# Access Compliance Report

## Public Rights-of-Way

Intersection ID: 10035551	Main Street: REA_RD	Cross Street: N/A	Location: NE
ADA ID: EC4DF8B5C818	Ramp Type: ParaDiag	Initial Pass/Fail: Fail	Overall Compliance: No
		Severity Score: 10

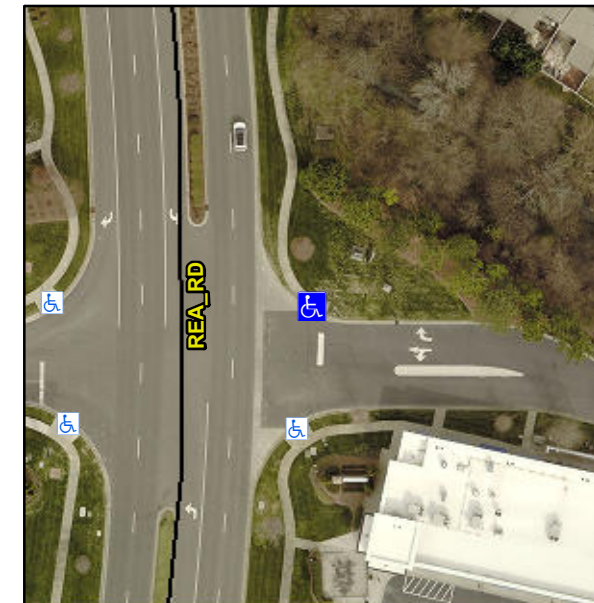
**LT RP < 5%**

**R304.5.1, R304.5.3**

**Remove & Replace Curb Ramp With Two New Directional Ramps or Equivalent.**
